MIL-S-83731/21A(USAF)
AMENDMENT 2
16 December 1996
SUPERSEDING
AMENDMENT 1
4 September 1991

MILITARY SPECIFICATION

SWITCH, TOGGLE, MINIATURE, LEVER SEAL, PANEL SEAL,
FOUR POLE LOGIC LOAD TO 5 AMPERES

This amendment forms a part of MIL-S-83731/21A, dated 20 March 1987, and is approved for use by all Departments and Agencies of the Department of Defense.

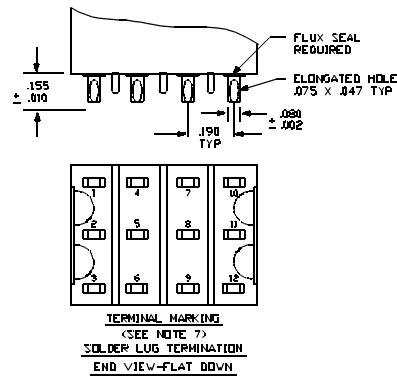
* FIGURE 1, top right view, dimension ".185 TYP": Delete and substitute: ".185 ±.015"

* FIGURE 1, end view : Delete and substitute:

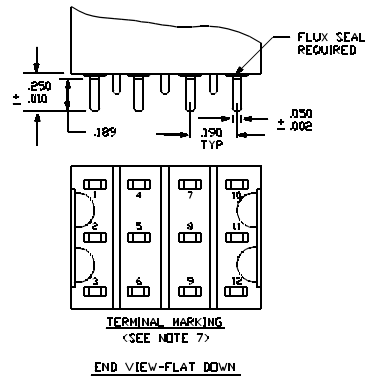
* FIGURE 1, top right view, dimension ".185 TYP": Delete and substitute: ".185 ±.015"

* FIGURE 1, end view : Delete and substitute:
